Title of Change:	PQFN56 Dual Cool Marking Layout Update
Effective date:	06 Dec 2022
Contact information:	Contact your local onsemi Sales Office or KrisJudelo.Dayna@onsemi.com
Type of notification:	This Product Bulletin is for notification purposes only. onsemi will proceed with implementation of this change upon publication of this Product Bulletin.
Change Category:	Marking
Change Sub-Category(s):	Shipping/Packaging/Marking

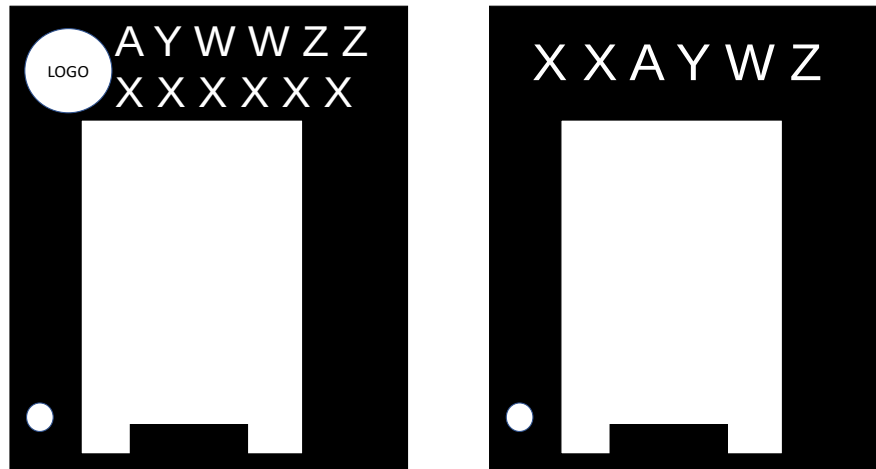
In order to improve quality of marking and its legibility. We are moving towards simplification of the layout.
Below is the summary of the changes.

Existing Layout	New Layout
Logo	Yes	No
Plant Code	Yes (A)	Yes (A)
Date Code	Yes (YWW)	Yes (YW)
Lot Code	Yes (ZZ)	Yes (Z)
Device Mark	Yes (XXXXXX)	Yes (XX)

Please note that "ON" logo will be removed on the new layout.

Character Measurement Change

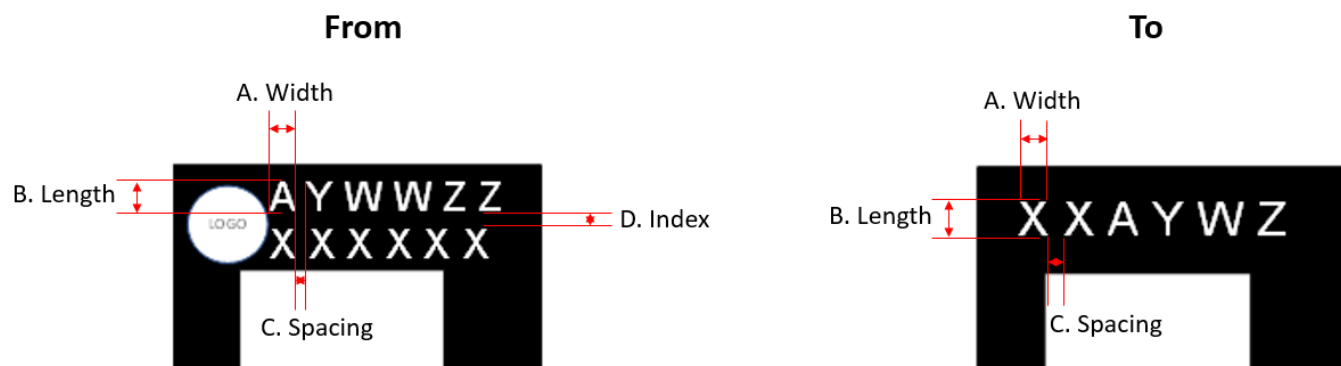
From	To
A. Width	0.36 mm	0.41 mm
B. Length	0.47 mm	0.64 mm
C. Spacing	0.08 mm	0.19 mm
D. Index	0.05 mm	NA

Note: Measurement are estimated values.
